Amphenol Taiwan Corporation

Product Change Notification

Part Numbers Concerned :	G40H3132211HR G40H3132211HR-C G40H3132211HR-D G40H3132211HR-F G40H3132212HR G40H3132212HR-B G40H3132212HR-C G40H3132212HR-F G40H313221HR-C	Originator:	Walter Chien
Product Description:	Mini SAS HD V/T SMT 2wall 1*1 port Series	Issue Date:	Aug. 31, 2020
		PCN NO:	P-20-083101
Distribution:	Change of spray code position

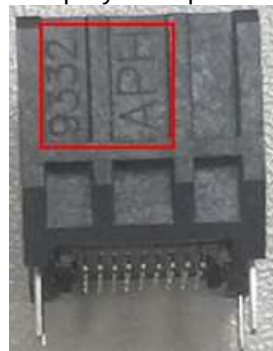
Spraying the code change:

Change spray code position from the side to the front

Before: Spray code position in side

After: Spray code position in Front

Spraying code is a manual process at present, Amphenol would like to incorporate it into the automatic assembly line to improve the process stability, the code position will be changed from the side to the front, and the code "Amphenol" will be update to "APH", This change will not impact the function of the product.

The front spray code products instead of side by running change from 2020/12/1
